SUBJECT: Environment Act Proposal – Rural Municipality of Franklin Water Supply System
Expansion (Client File No. 5690.00)

**SUBJECT: EAP RM of Franklin Water Supply System Expansion
RM of Franklin
File 5690.00**

Environmental Act Proposal
 EAP RM of Franklin
 Water Supply System Expansion
 File 5690.00

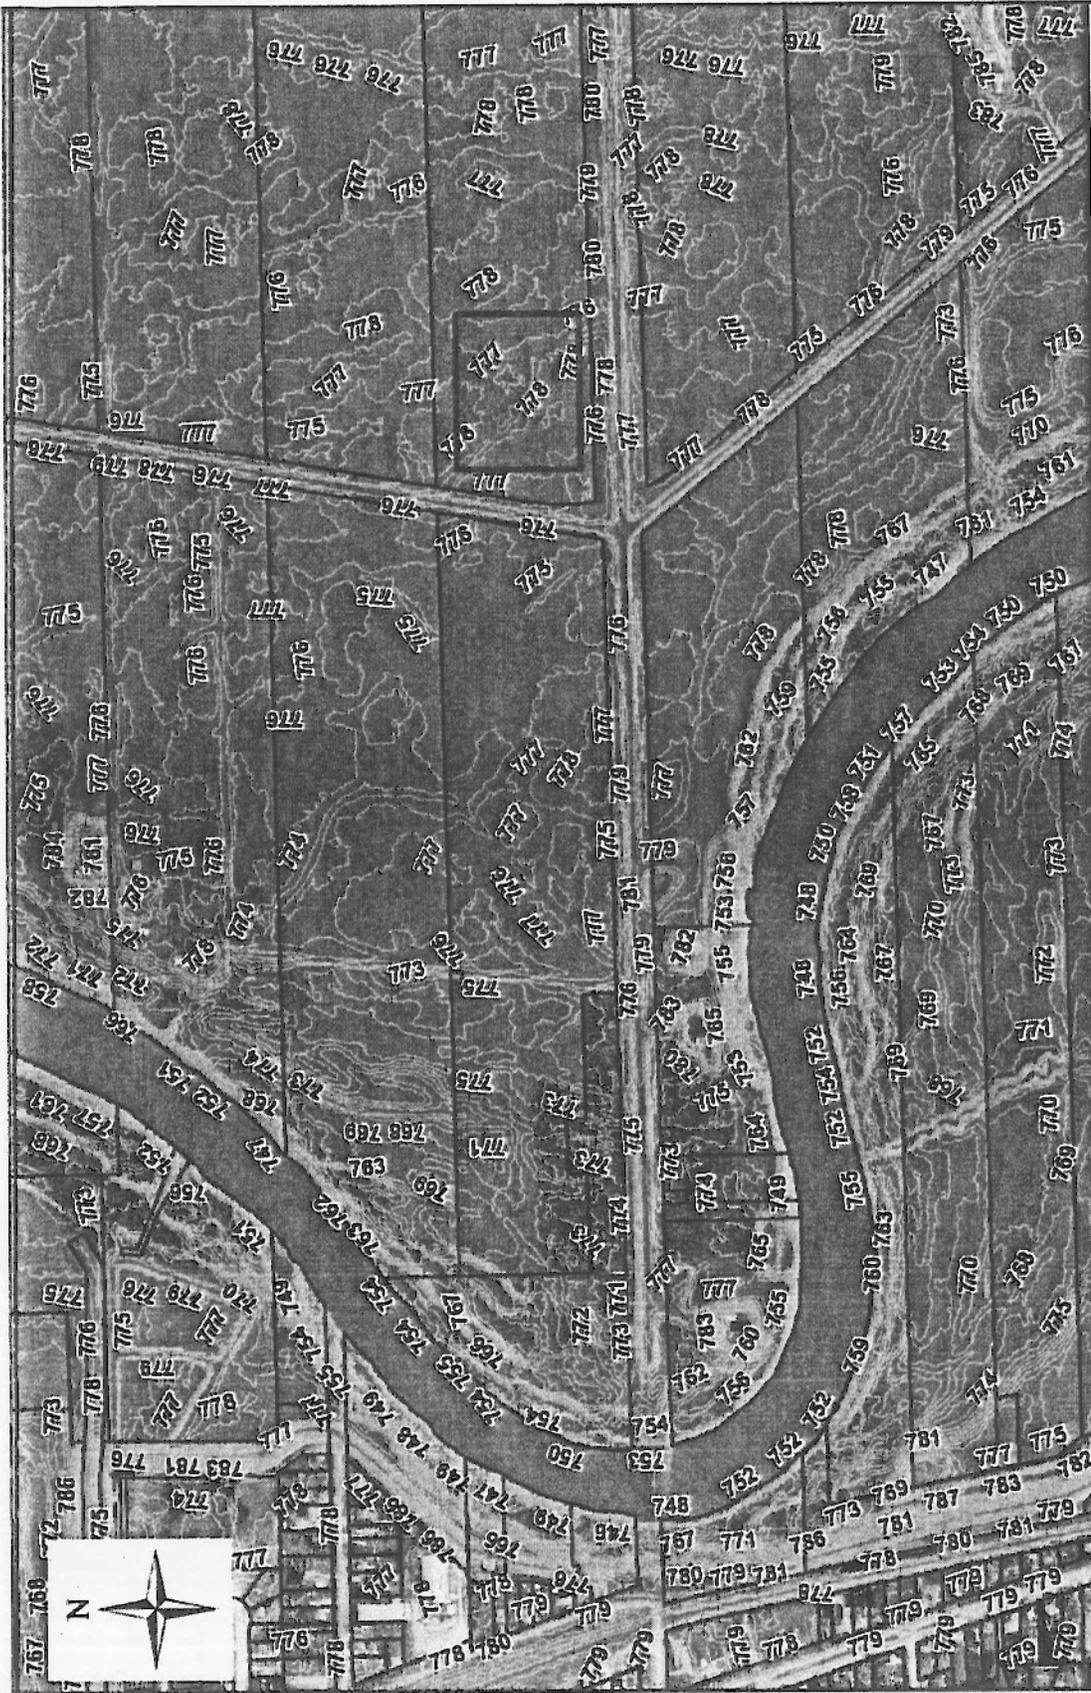
The proposed potential booster station site, as identified in the EAP Detailed Drawing, is located within the Red River Valley Designated Flood Area (RRVDFA). Aerial photographs (attached) taken during the 1997 and 2009 Red River Floods indicate that the property was completely inundated during both flood events.

Natural ground elevations at the site, obtained by LiDAR, range from approximately 236.5 to 237.1 metres (776 feet to 778 feet), G.S. of C. Datum. The 1997 flood level, the equivalent of a 100 year flood event, reached an elevation of approximately 239.0 metres (784.2 feet), G.S. of C. Datum at this location. The corresponding Flood Protection Level at this location is approximately 239.6 metres (786.2 feet) G.S. of C. Datum.

Hydrologic Forecasting has no objections to the EAP for the purposes indicated. However, in accordance with Manitoba Regulation 59/2002 and Section 17 of the Water Resources Administration Act, a RRVDFA Permit for the structure must be obtained from this office and flood protection must be provided for the booster station.
